APPENDIX 2.5

FURTHER INFORMATION

2530
DATA CENTRE

Design Statement – Response to Further Information Request (FI 25/60344, Section 13)

Conceptual sketch showing new screening and office end

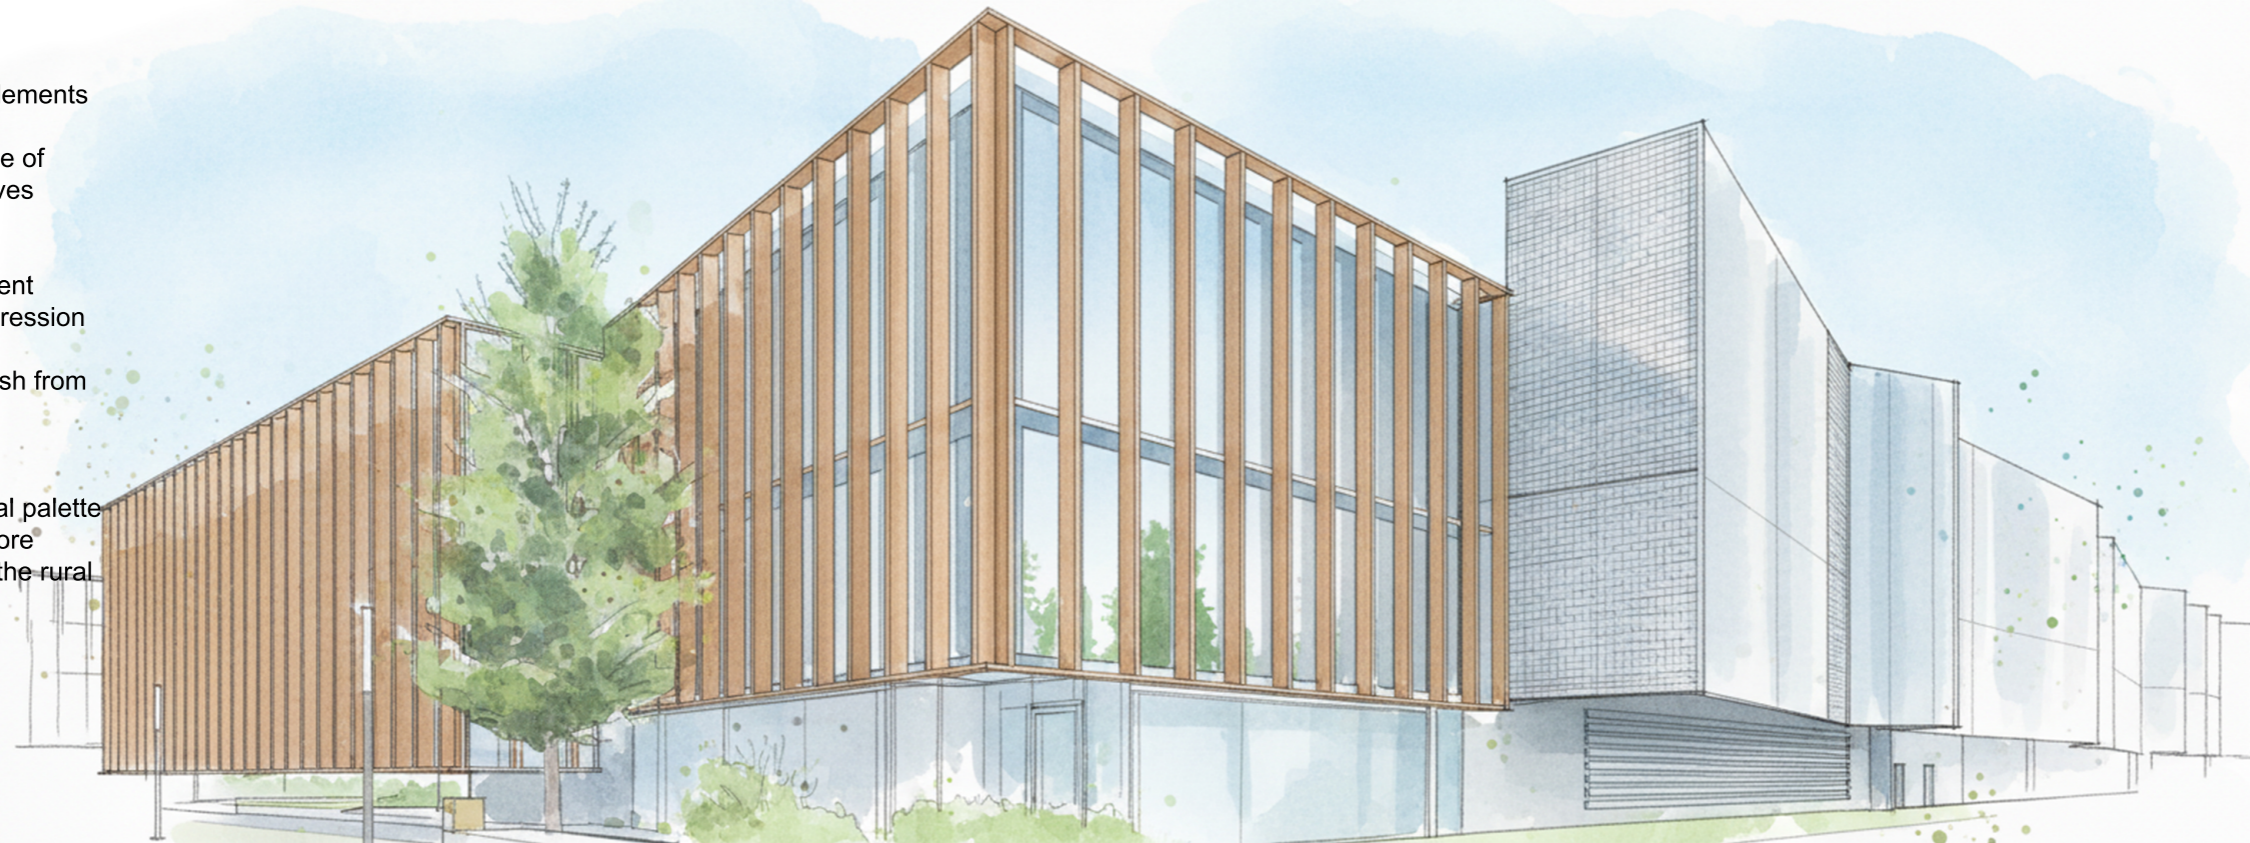
Use of vertical elements

Increases the use of glass and improves daylighting

Provides a different architectural expression

Easy to distinguish from the rest of the development

Include a material palette that responds more appropriately to the rural context

Metallic materiality

Suggestive angles and shapes

Avoid monolithic forms

Breaks the scale

Grounds the building

Adapts to the operational doors and the topography

CAMPUS

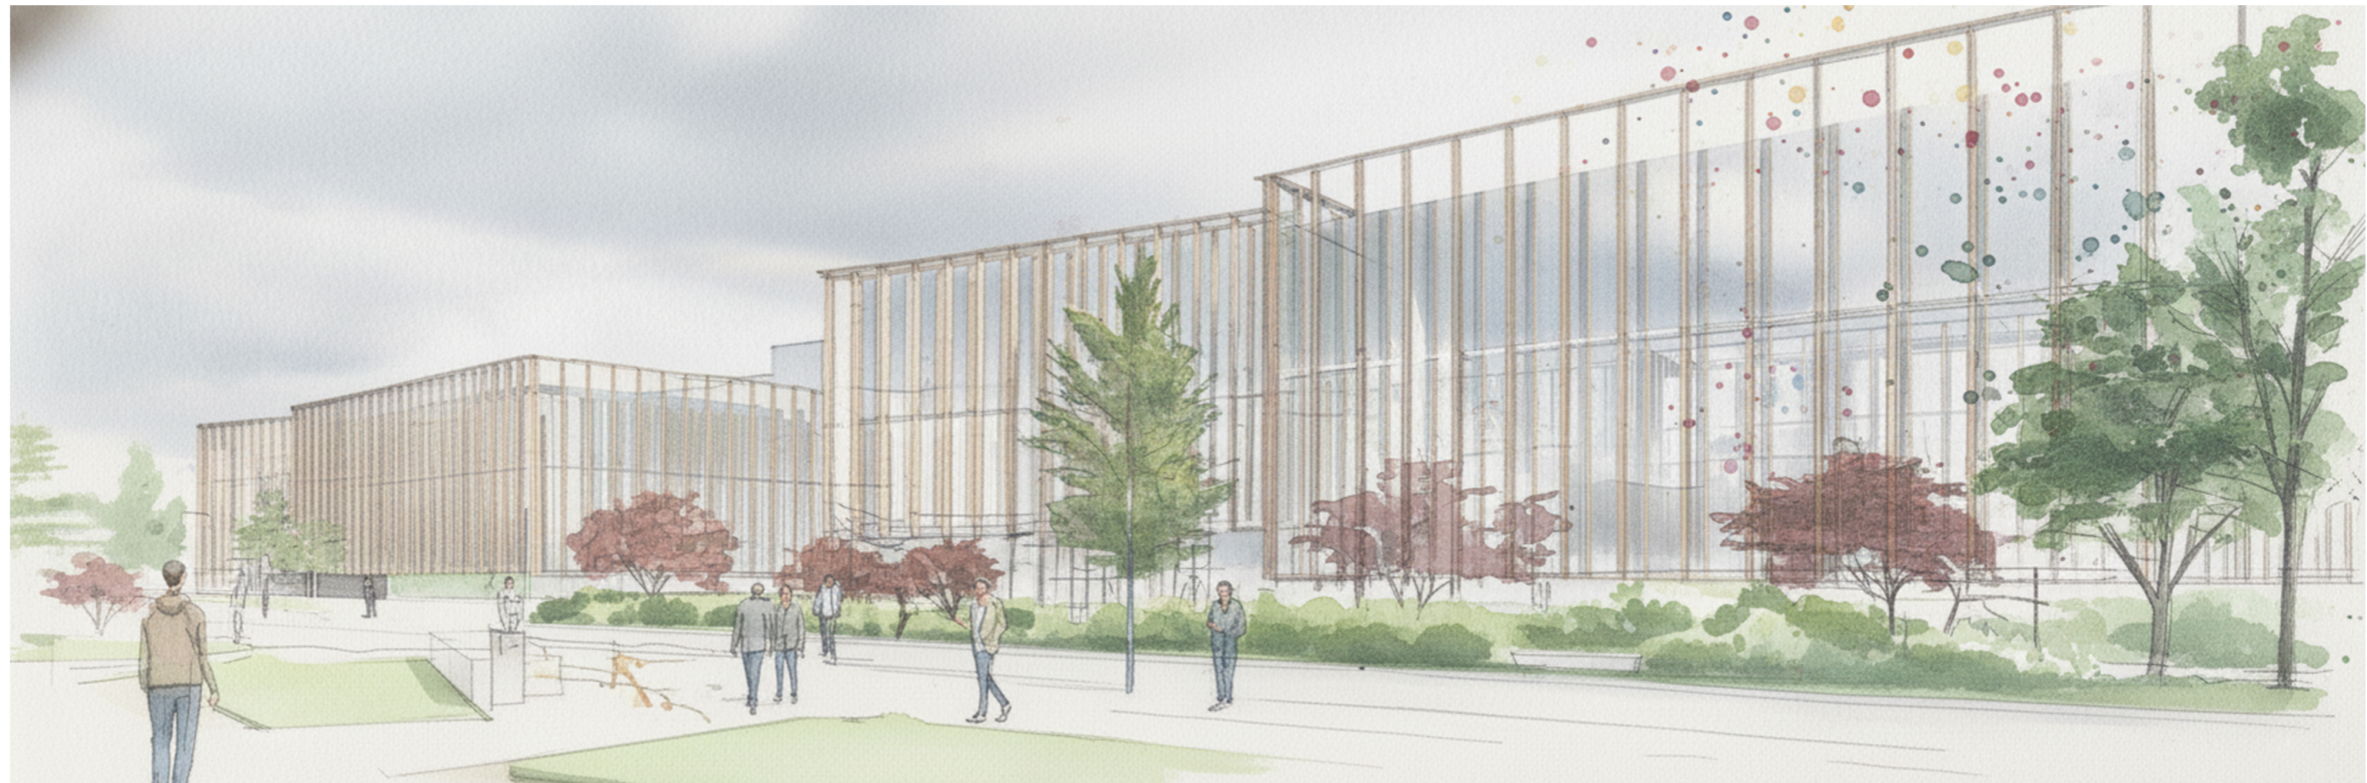
Generates a 'plaza' feeling

Introduces hard and soft landscaping

Grouping the offices together generates a development core

Results in a more human-friendly architectural appearance

Includes native Irish species which connects with the rural environment
